SITE AND ARCHITECTURAL REVIEW COMMITTEE
TUESDAY, MARCH 22, 2016
5:15 p.m.

Subject: Pruneyard Project

File No.: PLN2015-76:79/335/357:359

ARCHITECTURAL PLAN REVIEW of the PRUNEYARD

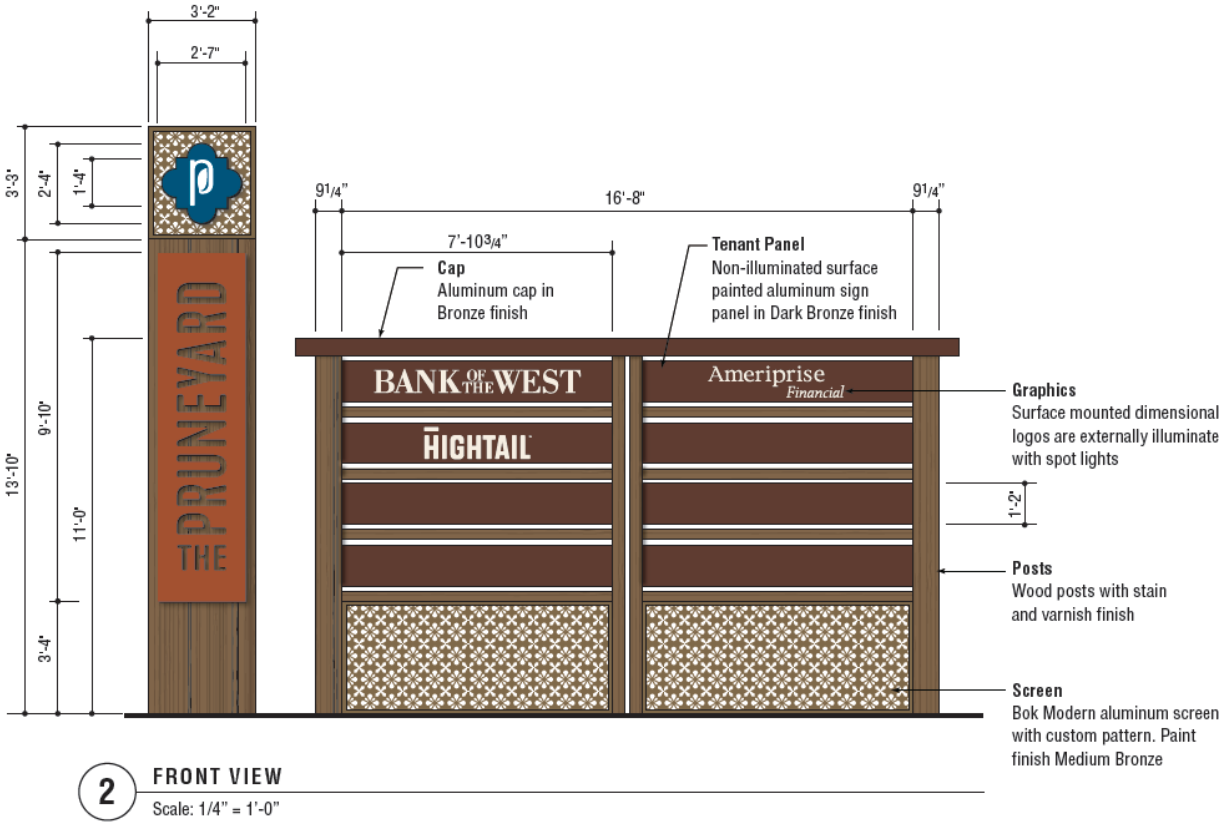
- **Free-Standing Signs**: The new free-standing signs are more contemporary than the existing sign structures. In addition to being smaller, the new signs are metal framed with a customized pattern to create a distinct branding image for the Pruneyard. This approach is somewhat unique as most free-standing signs are designed to match the appearance of the main buildings in terms of materials and colors. However, the distinct design would result in a higher quality signage presence along Campbell and Bascom Avenues.
